**Evaluation of proposed reallocation for Water Right No 39709**

Proposed: Move water right no. 39709 a distance of 2631 ft to the southwest.

## WELL TEST ANALYSIS

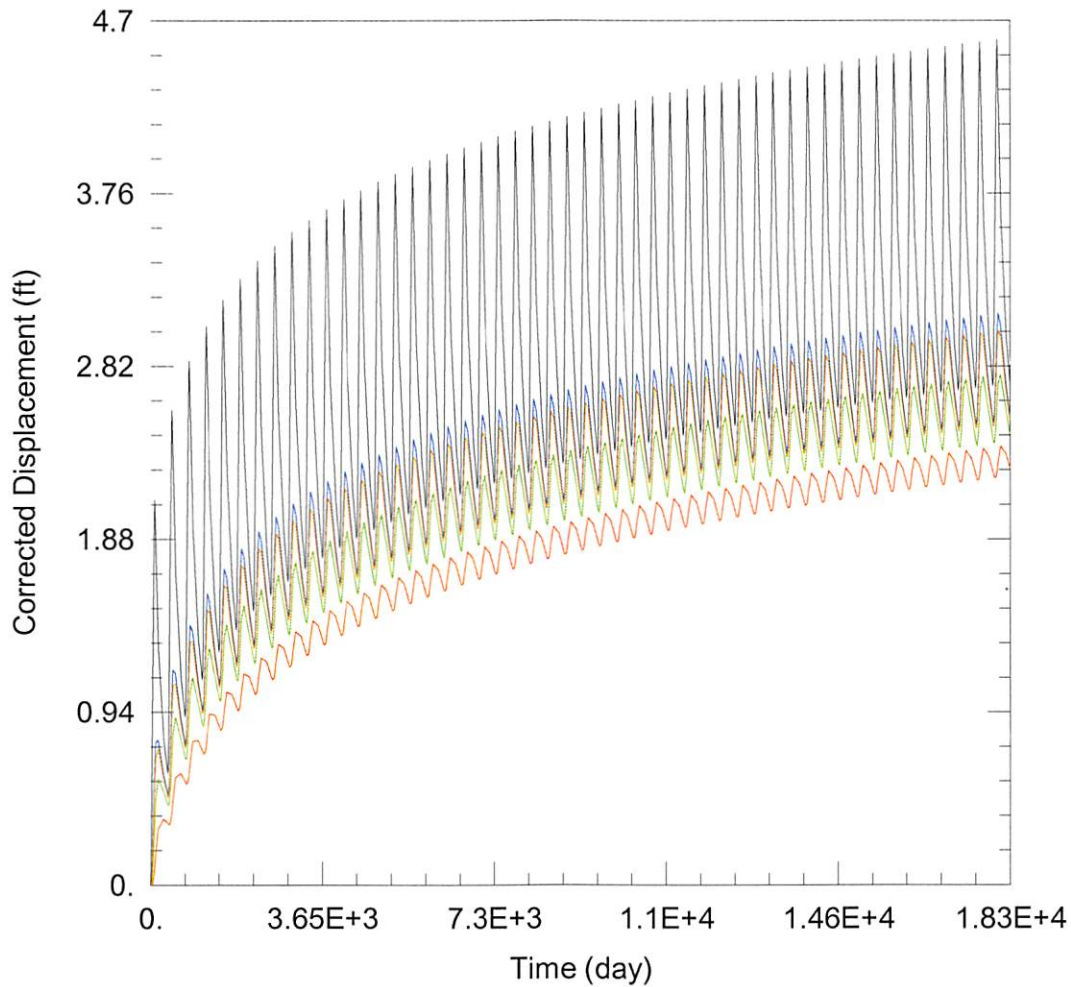
$S = 0.1457$, $T = 4570$ ft$^2$/day, $tp_{current} = 105$ days (based upon observed rate and reported quantity), $Q_{current} = 865$ gpm (based upon observation during 2017 field inspection), $tp_{proposed} = 76$ days, $Q_{proposed} = 865$ gpm.

| 11906: | Drawdown from current location = 4.23 ft |
| | Drawdown from proposed location = 3.11 ft |
| | Net drawdown = **-1.1 ft** |
| 27188: | Drawdown from current location = 3.40 ft |
| | Drawdown from proposed location = 2.39 ft |
| | Net drawdown = **-1.0 ft** |

| 19712: | Drawdown from current location = 3.79 ft |
| | Drawdown from proposed location = 2.77 ft |
| | Net drawdown = **-1.0 ft** |
| 12195: | Drawdown from current location = 2.15 ft |
| | Drawdown from proposed location = 3.01 ft |
| | Net drawdown = **0.9 ft** |
| Domestic 23-32-31: | Drawdown from current location = 2.99 ft |
| | Drawdown from proposed location = 4.60 ft |
| | Net drawdown = **1.6 ft** |

None of the net well effects exceed the drawdown allowance of 3.5 ft, therefore none of the neighboring wells are likely to be impaired.

The proposed move will decrease drawdown effect to 3 of the 5 neighboring wells. The increased effect on water right no. 12195 and the domestic well in section 23-32-31 are well within the 3.5 ft drawdown allowance. The proposed change is not likely to unreasonably contribute to an impairment situation. Therefore, GMD3 staff recommends approval of the application.
